Fanellan 400 kV Substation and Converter Station

Environmental Impact Assessment Report

Volume 2 | Chapter 12 – Traffic and Transport, Addendum

October 2025

Figure 12.1: Potential Beaufort Route

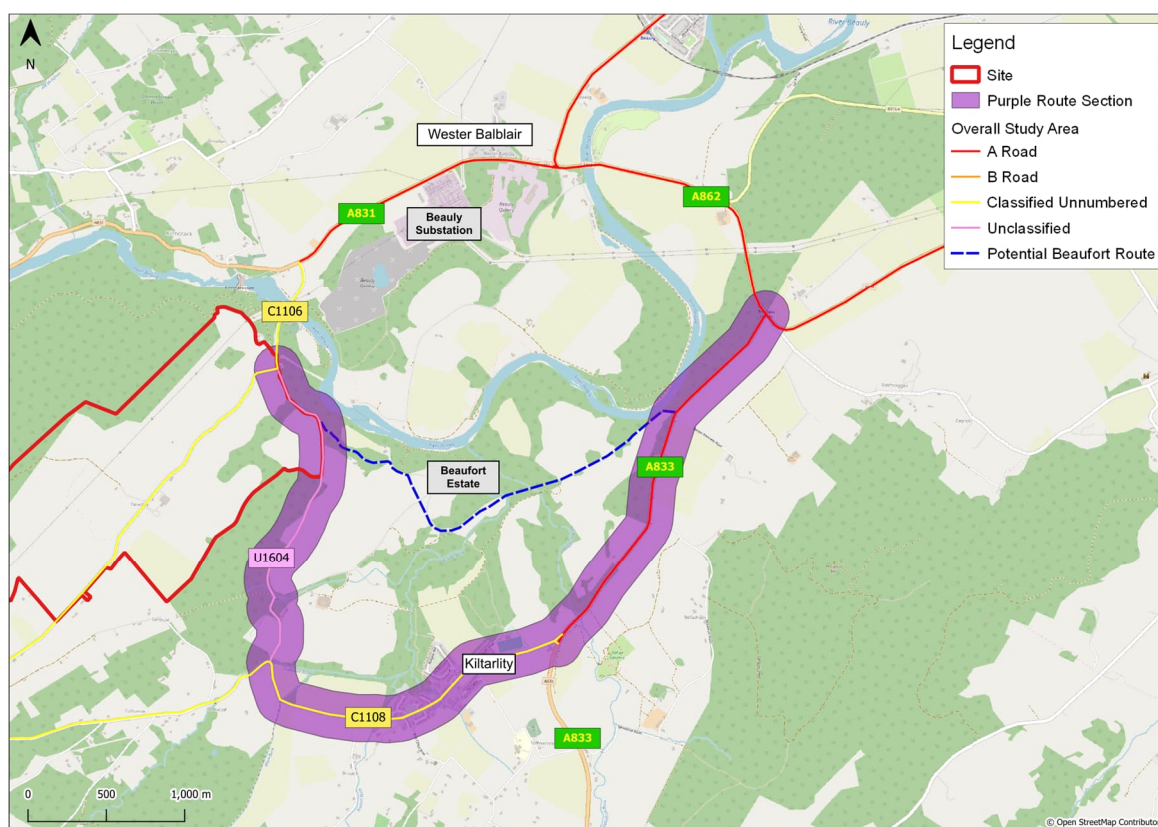
12.2.1 In response to the above THC consultation discussions, a new potential construction route through Beaufort Castle (the Beaufort Route) has been developed, which is specifically intended to mitigate the impact on Kiltarlity. Further details of the potential Beaufort Route are presented in the TA and a visual representation of its alignment is shown in Figure 12.1.

12.4.1 In response to THC comments questioning the suitability of routing traffic along the C1108 through Kiltarlity, a potential Beaufort Route has been introduced as a mitigation which would allow for a significant portion of construction traffic to avoid Kiltarlity for Phase 1. This is anticipated to reduce the environmental impact from construction traffic on Kiltarlity. This addendum has therefore been prepared to demonstrate the impact on the seven key characteristics following the introduction of the Beaufort Route.
